### **DESIGN/PROCESS CHANGE NOTIFICATION**

Description of Change (From) :  
For TO3PF-3L package assembly in FSSZ  
Retract mold type: hole with EMC filled.

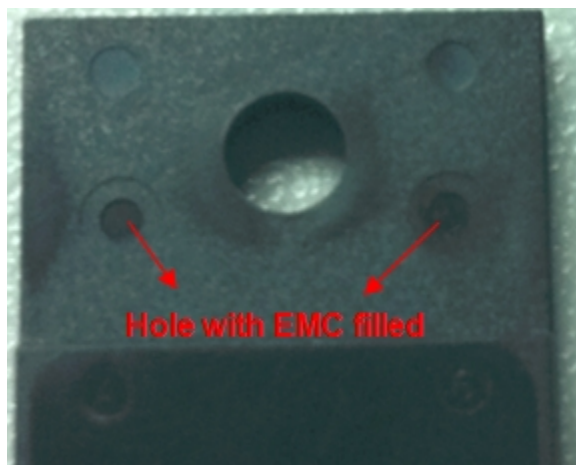
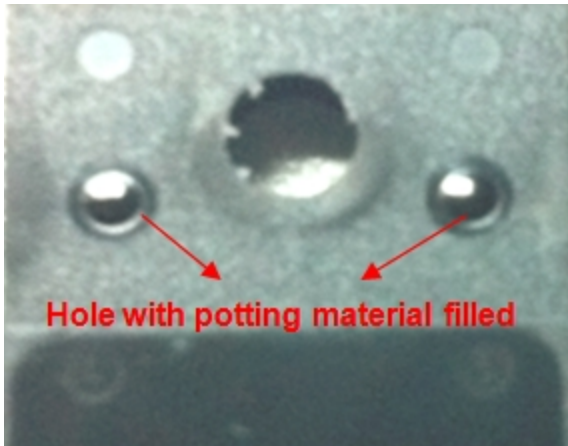
Description of Change (To) :  
Add alternative type of potting: hole with potting material(epoxy) filled.
